Office Action Summary

10/760,253

SILVERBROOK ET AL.

DETAILED ACTION

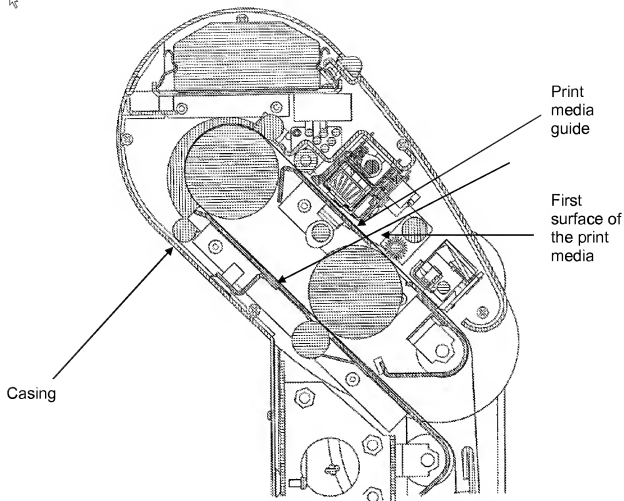
As per claim 1: a casing in which the at least one printhead module is removably mounted a print media guide mounted to a slanted portion of the casing immediately adjacent the channel, a slanted print media contact surface of the print media guide arranged to contact and guide the print media across the nozzles of the printhead module for printing onto the first surface (shown below).

As per claim 2: a print media guide is arranged to substantially prevent the print media from impinging on the nozzles of each of the at least two printhead integrated circuits (see figure below – media guide and rollers put pressure on paper so that it rests against the media guide and not the nozzle area).

As per claim 3: the print media guide is arranged to provide a gap between the nozzles of each of the at least two printhead integrated circuits and the passing print media (see figure below – media guide and rollers put pressure on paper so that it rests against the media guide and not the nozzle area).
